Staff Report Presented to the Planning Commission
Continued to the September 5, 2024 Planning Commission Meeting

REQUEST: The applicant is requesting to subdivide an approximately 282,704 square foot (6.49 acre) property into ~~29~~ 27 residential lots, 1 storm detention lot and associated roadway and utility improvements. The subject property is to the east of 23rd Avenue and west of 27th Avenue and is identified by Linn County Tax Assessor’s Map No. 13S01E32CA Tax Lot 4403. Lot sizes would range in size from ~~7,206~~ 7,309 square feet to ~~8,626~~ 12,478 square feet. All lots would be eligible to be developed with single, family dwellings and/or duplexes [SHMC 17.10.020(A and B)]. The subject property is in the Residential Low Density (R-1) Zone.

FILE NUMBER: SD24-01

REPORT DATE: August 27, 2024

PRELIMINARY LOT PLAN
TENTATIVE SUBDIVISION
TAX MAP: 13501E32CA
LOT: 04403
SWETHOME, OREGON

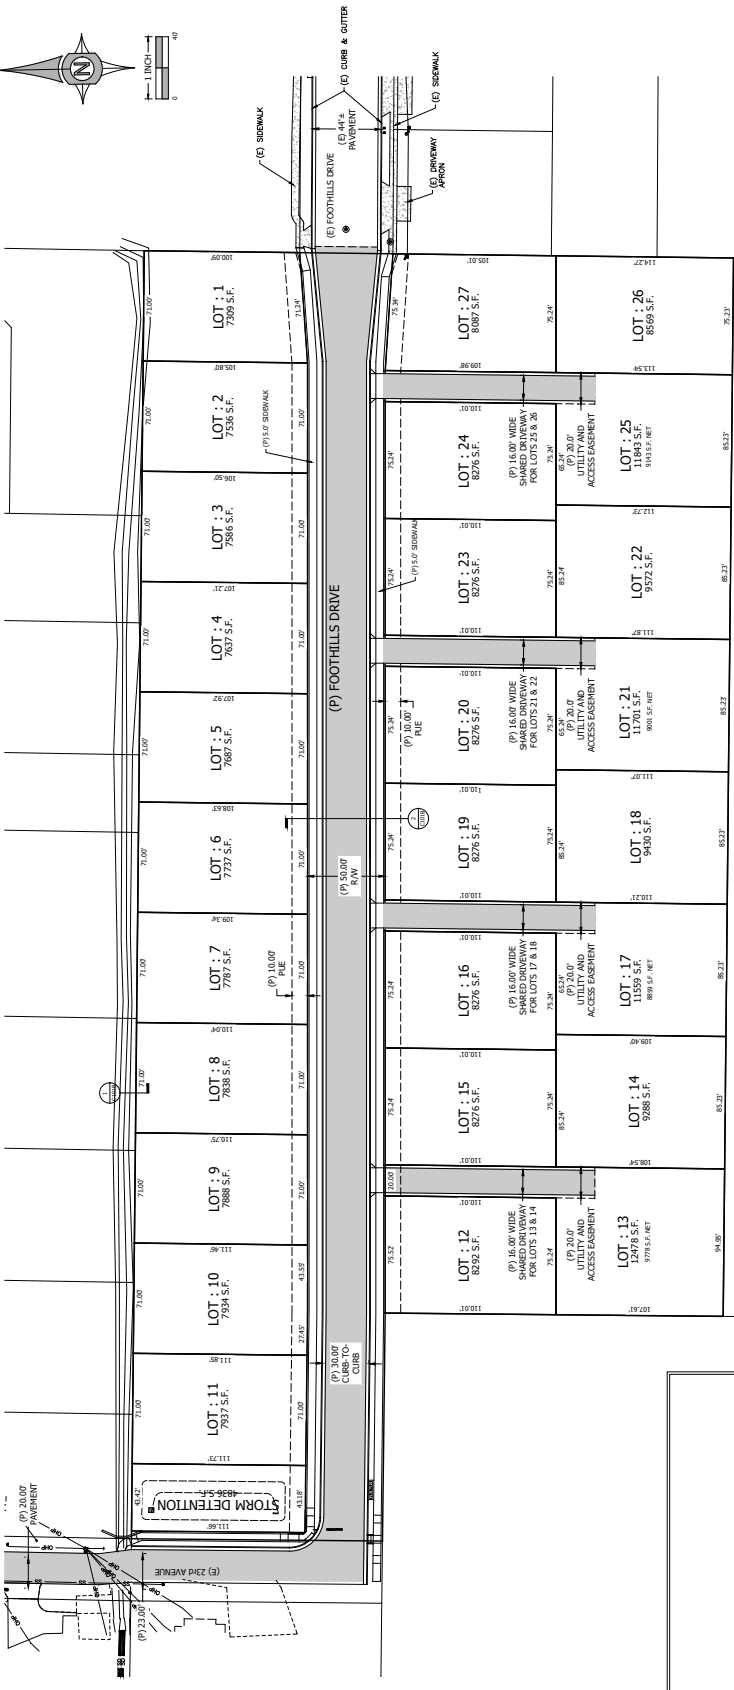
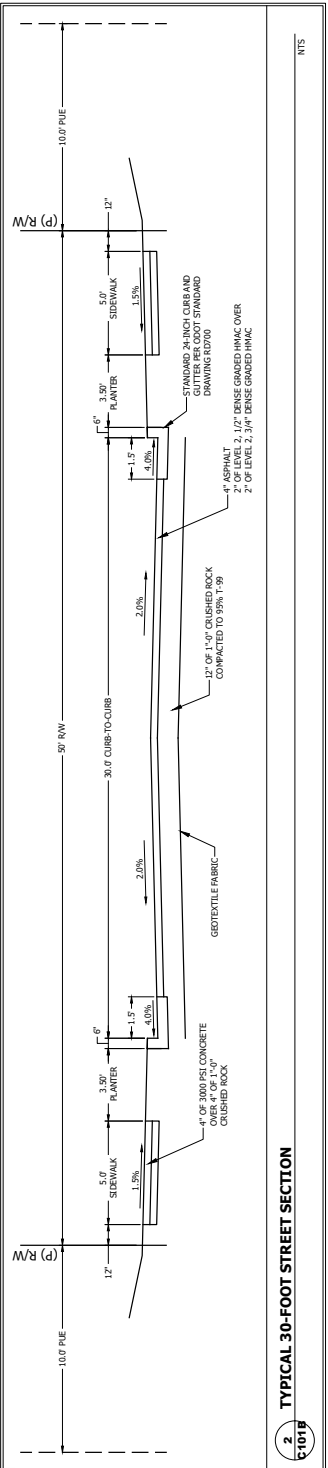
The City of Sweet Home wants to have provision for a waterline easement in the common driveway serving Lot 20 26 on Lot 24 25. The easement would be the same size as the proposed shared utility and access easements as noted on the proposed site plan. The easement would run from the south right-of-way line of Foothills Drive to the south line of Lot 20 25. The City is looking forward 15-20 years to a need for an additional water reservoir in the area, with the adjacent property to the south at the right elevation and location. It has access from Ames Creek Road, so that only a waterline would be connected through the lots. We would likely place a conduit in the ground at the time of construction to feed the future waterline through, without the need for excavation at that future time.

We will need to see improvements in the width of the property on the 23rd Avenue side. The plan indicates a curb and sidewalk along the east side of 23rd Avenue. That would be a "half street" which is really a "3/4 street" on the ground, comprised of sidewalk, curb and drainage, pavement to the centerline and the opposite lane. There will need to be curb on that side too because residents will travel to

Additional Comments regarding the amended site plan, emailed on August 27, 2024: No utilities are shown, so hopefully they can show me the corrections I needed to see. What's more, it looks to me like our future water tower easement that ran through lots 26 & 27 is completely gone now, additionally, no outlet easement is shown from storm detent to ditch north of the subdivision.

Attachment B C, Sheet C102 shows the access and utility easements as shared driveways for all lots abutting the easements.

Attachment B C, Sheet C102 shows a 3-foot planter strip.

4. The applicant shall provide a public waterline easement through Lot ~~24~~ 25 in the common driveway that serves Lot ~~20~~ 26. The easement would be the same size as the proposed shared utility and access easements as noted on the attached site plan (Attachment B C). The easement would run from the south right-of-way line of Foothills Drive to the south line of Lot ~~20~~ 25, and shall be shown on the final plat.

8. The applicant shall either provide an easement on the adjacent Lot to the storm water detention area (751 23rd Avenue) or provide a public right-of way connection to provide a connection from the storm water detention area to the storm water ditch.

9. The applicant shall provide stormwater collection easement along Lots ~~12-20~~ 13-26 to accommodate the run-off from the south hillside. The storm water collection will be through the utility easements to Foothills Drive.

From: [Laura Laroque](#)
To: [Angela Clegg](#); [Blair Larsen](#)
Subject: QPI alterative lot layout
Date: Saturday, August 24, 2024 7:53:56 AM
Attachments: [23-102 QPI Foothill Alt B.pdf](#)
Importance: High

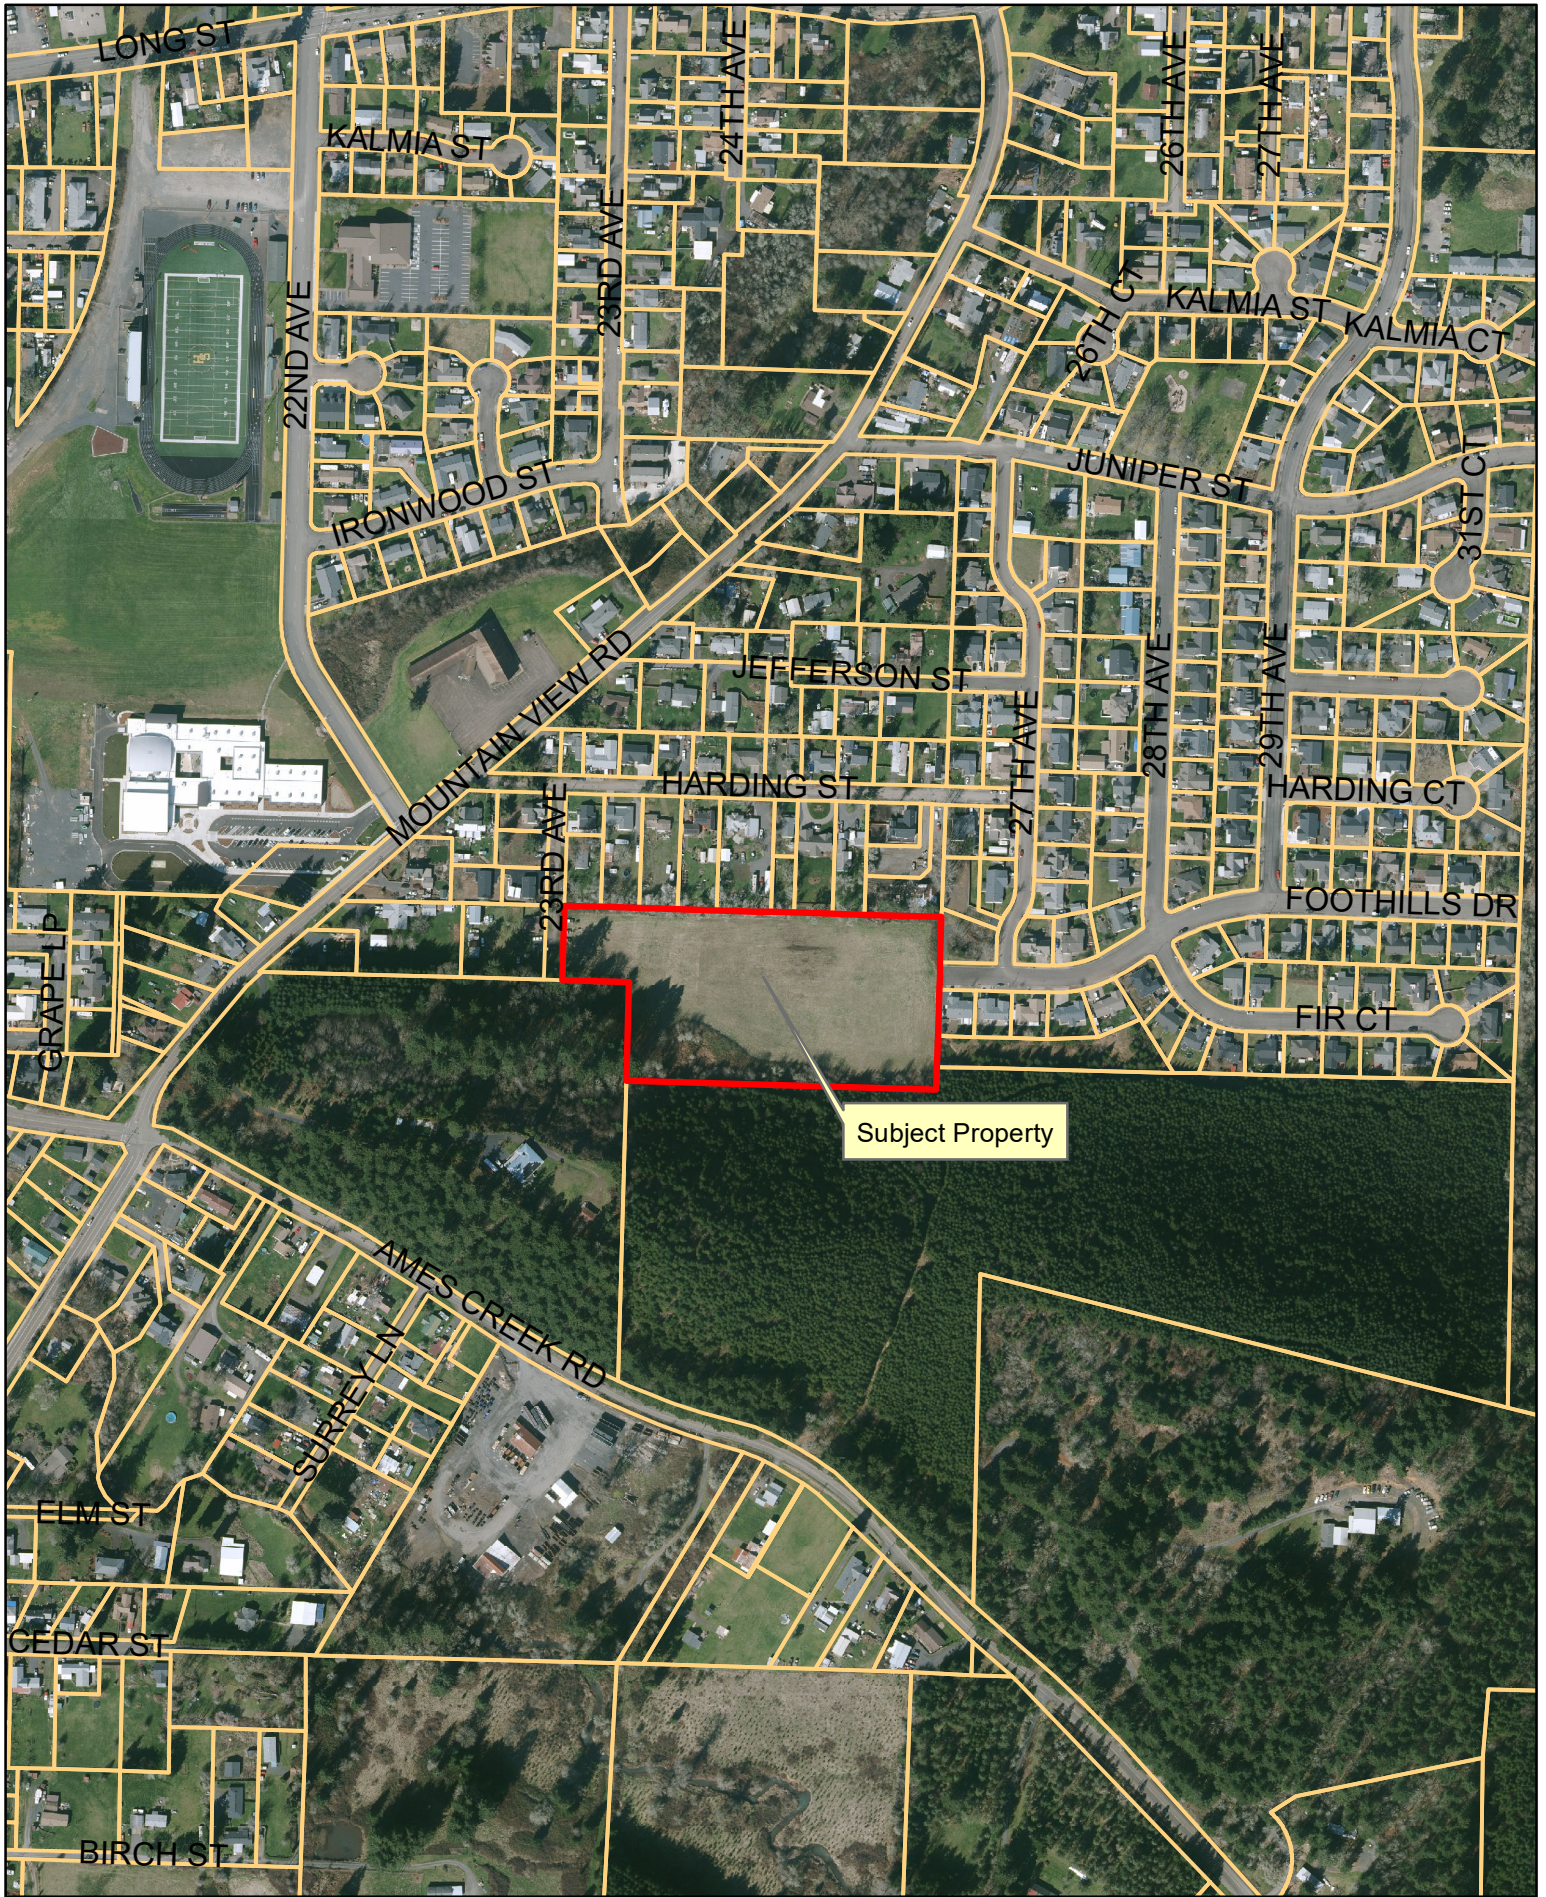
Sorry for the delay on this. Attached is an alternative lot layout for this subdivision. In this layout lots 13, 17, 21, and 25 are flag lots and lots 14, 18, 22, and 26 are access via easement. The 10% standard for subdivision lots accessed via easement is only slightly exceeded in this scenario (3 lots vs. 4 lots proposed and 10% vs 15% proposed). Additionally, the variance request for the lot width measurement is no longer necessary.

We explored a cul-de-sac design as Joe Graybill suggested. However, we then discovered that the Sweet Home development code discourages the use of cul-de-sacs where other reasonable alternatives exist. In this case, we feel that that the attached alterative design is a “reasonable alternative” to a cul-de-sac.
